Moolarben Coal Expansion

On the 6 April 2018 the NSW EPA requested assistance from OEH SD with a strategy for discharges into the Goulburn River catchment, considering proposed modifications to the Ulan and Moolarben Coal Mines. On the 10 April 2018 the NSW EPA, OEH SD and DPE met with Moolarben Coal representatives to discuss issues raised in relation to the Moolarben Coal Expansion. On 28/05/2018 the NSW EPA wrote to OEH SD requesting a review of the Response to Submissions (RTS) for the Moolarben Coal expansion (Moolarben Coal 2018). The current report has been written to address the EPA's request to review the RTS for the Moolarben Coal expansion.

Adequacy of response to issues raised by EPA/OEH on the Moolarben Coal expansion

Figure 2. Flow exceedance curves for Stn210046 (red line; 10/3/1956 to 31/8/82) and SW01 (black line; post November 2008) left; and time series plot of SW02 flows right. Source: Pinneena Database (210046) and UCML AEMR 2008-2016.

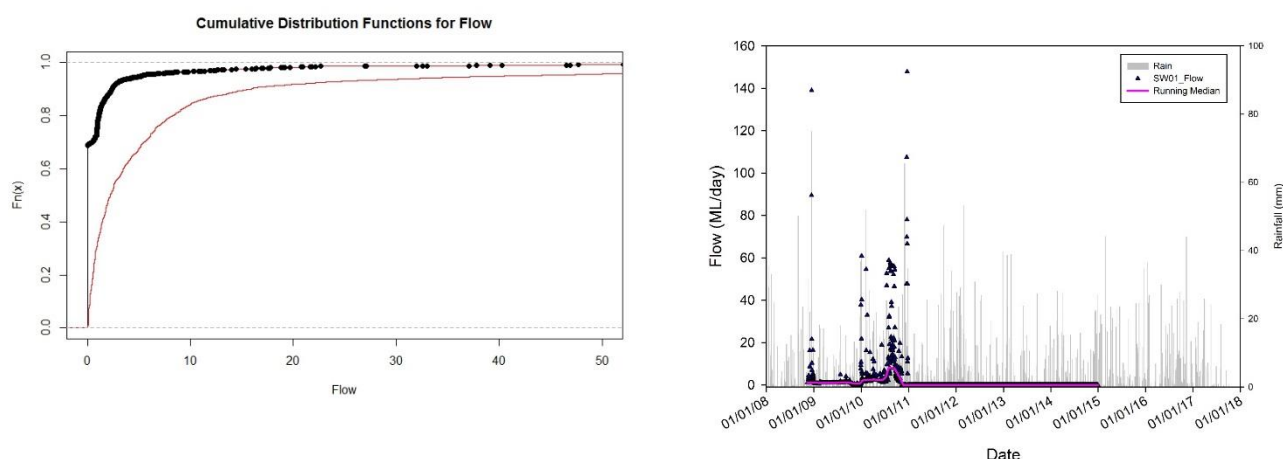
Median flow for the Water Resources Gauge (210046) over the period 10/3/1956 to 31/8/1982 was 2.225 ML/day (see the flow exceedance curve below; Figure 2). The significant reduction in recent

upstream flows at SW01 is quite noticeable (Median flow for SW01=0 ML/day for the period post November 2008). In fact, no flows were recorded at SW01 since the beginning of 2011 (see UCML AEMR's for 2011, 2012, 2013, 2014, 2015) and flow at SW01 was no longer reported in the 2016 UCML AEMR, despite the obvious rainfall related responses at SW01 in 2009 and 2010 (Figure 2). Either the gauge is non-functional or no water is currently being released/flowing from upstream. An explanation of these recent flow results for SW01⁶ is required to understand the context for MCO discharges into the Upper Goulburn River.

Figure 3. Time series of flow and comparison of running medians for SW01, SW02, LDP6, LDP19 and Combined LDP6 & LDP19. Source: UCML AEMR 2008-2016 and UCML monthly monitoring reports 2017.

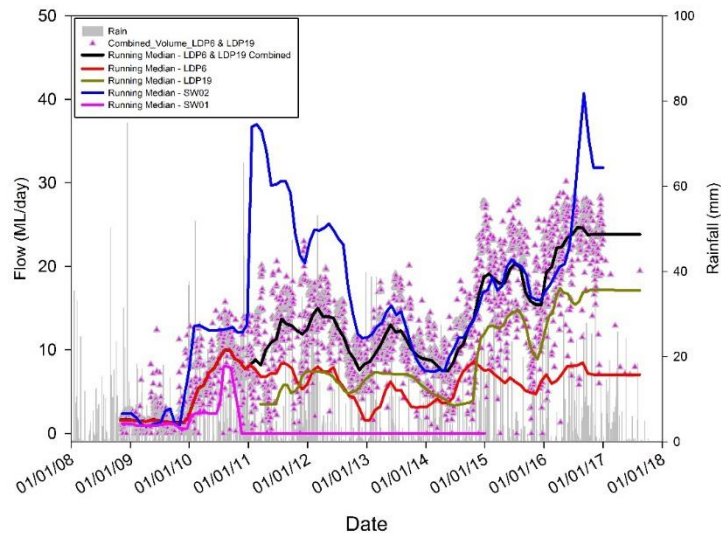
- LDP19 discharges initially commenced in March 2011, with a significant increase in flows in 2015. Median flows towards the end of 2016 were ~17ML/day⁷.
- The median of the combined flows from UCML LDP6 and LDP19 are currently about 24 ML/day (over 10 times the median flow recorded at Stn210046 for the period 10/3/1956 to 31/8/1982; OEH 2017)⁸.
- Throughout much of 2014-2016 the flows recorded at the downstream gauging station SW02 were largely sourced from Ulan LDP discharges⁹ (note overlap of black and blue lines in Fig 3 below).

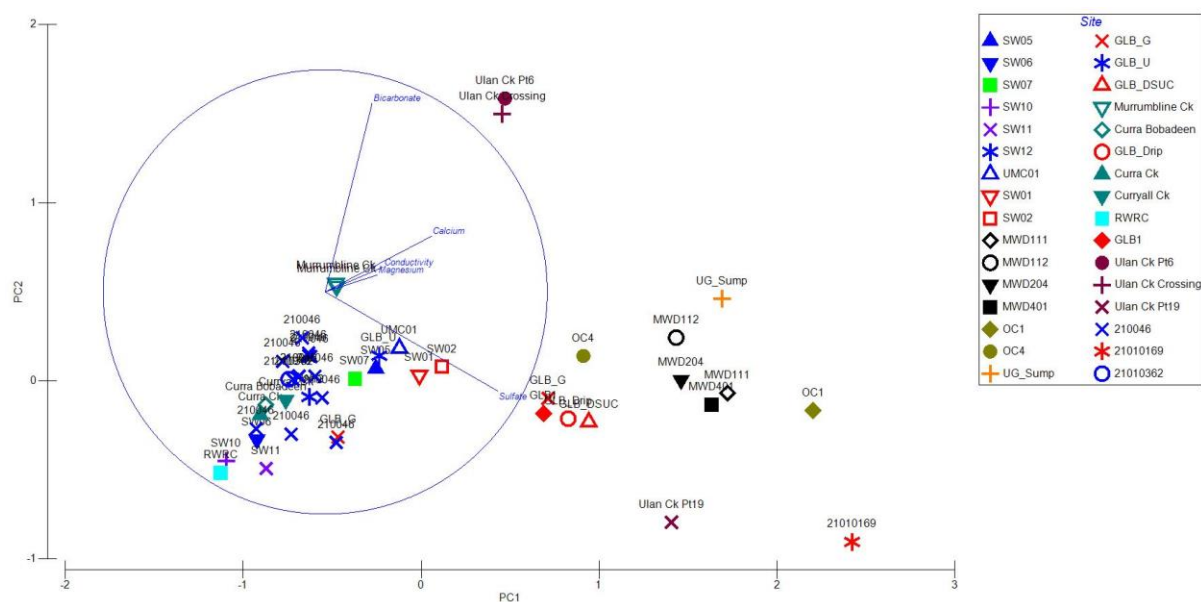
Figure 4 illustrates a principal components analysis and comparison of available ionic composition data for the area. Points closer together in this graph have more similar ionic composition than points further apart¹⁵. There are major differences between Goulburn River surface waters and the MCO dam storages, open cut pits and underground sump. It is also clear that UCML discharges and Goulburn River water downstream of these discharges¹⁶ have a very different ionic composition to the Goulburn River upstream of these discharges¹⁷.

The statement that “mine affected water stored in mine storages (for measured analytes) currently has a similar ionic make-up to surface water in the Goulburn River” is incorrect.

Figure 5. Electrical Conductivity concentration exceedance curve for SW01 (orange line), SW02 (purple line), LDP6 (black line) and LDP19 (blue line). Source: UCML AEMR 2008-2016 and monthly monitoring reports 2017.

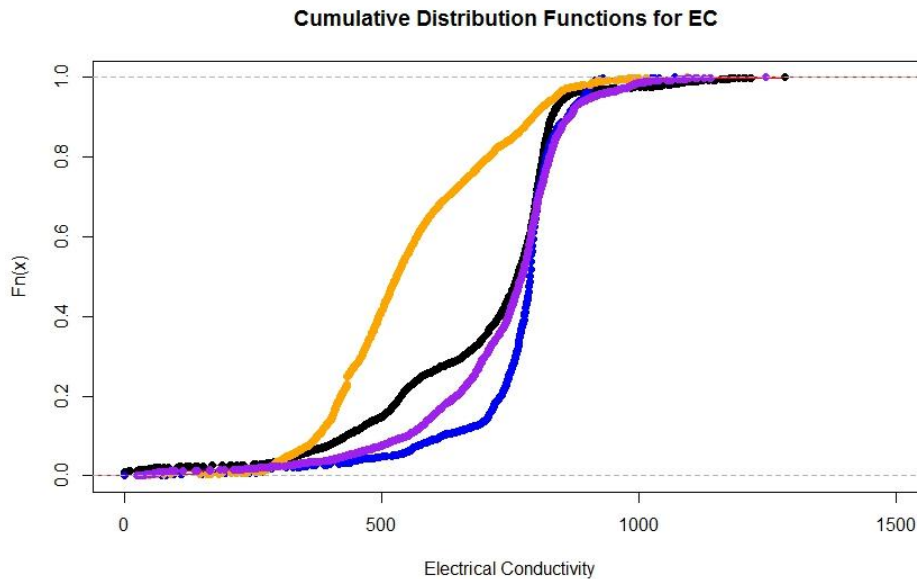
The distribution of EC levels measured at LDP6, LDP19, and SW02 clearly exceeded those at SW01 (see Figure 5). The median EC of the discharges and SW02²² were approximately 200 $\mu\text{S}/\text{cm}$ higher than that of the upstream site SW01.

Figure 6. pH exceedance curve for SW01 (orange line), SW02 (purple line), LDP6 (black line) and LDP19 (blue line). Source: UCML AEMR 2008-2016 and monthly monitoring reports 2017.

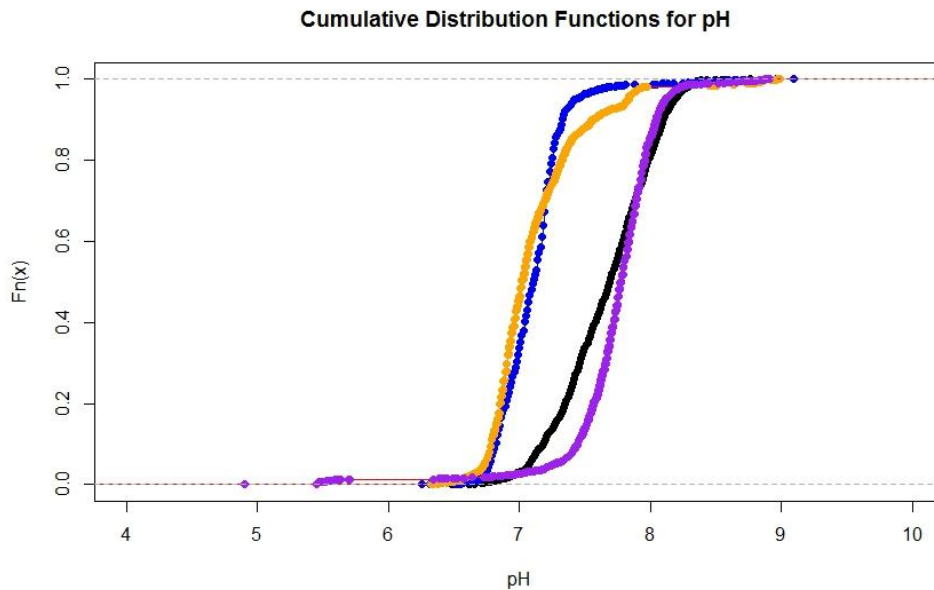
There were also significant differences in the pH of waters released from LDP6 relative to upstream SW01 waters (see Figure 6). It is interesting though that the distribution of pH levels of the LDP19 discharge more closely approximates those of SW01 than does LDP6 or SW02. Over the period 2009-2016, median pH levels for the monitoring sites were:

- LDP6= 7.7;
- LDP19= 6.9;
- SW01= 7.3; and
- SW02= 8 $\mu\text{S}/\text{cm}$.
